Aircraft Type: Slingsby T67 Firefly (T67A, T67B, T67C, T67C3, T67M, T67M Mk11, T67M200, T67M260, T67M-T3A)

Title: Slick Service Bulletin SB1-15A – Potential of decreased service life of Slick 4-cylinder magneto distributor gear assemblies.

SUBJECT: Potential decreased service life of Slick 4-cylinder magneto distributor gear assemblies. **Based on process and component improvements following the initial release of this service bulletin, the serial number range is being extended in this revision. Magnetos previously returned for compliance to SB1-15 must be returned or inspected for compliance to this revision SB1-15A.**

Figure 5. K3008 Distributor Gear With Monel Electrode

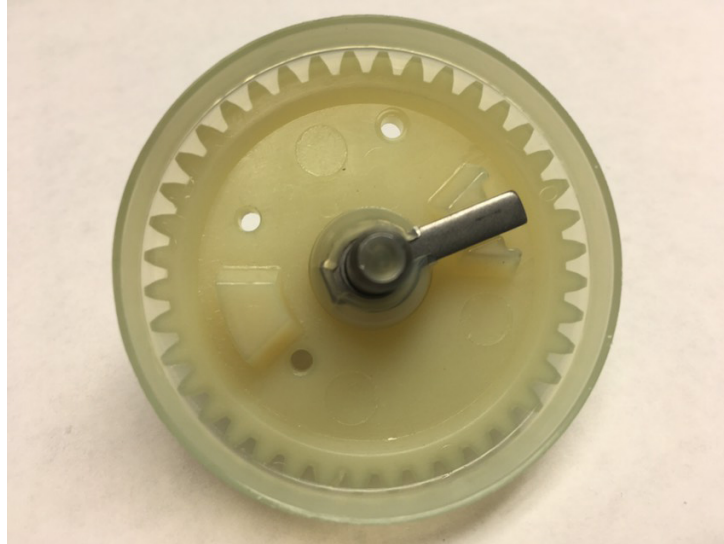
If it is not possible to confirm the version of the distributor gear that is installed in a given magneto from maintenance records, the magneto may be removed from the engine in order to have the housing and distributor block removed to allow visual inspection of the distributor gear. Distributor gears with Copper electrodes must be replaced with distributor gears with Monel electrodes.

COMPLIANCE: REMOVE affected distributor gear assembly in subject magnetos and REPLACE with replacement distributor gear assembly, K3008, as soon as possible, not to exceed the next 50 hours. Document Service Bulletin compliance as written entry in applicable Aircraft and/or Engine logbook.
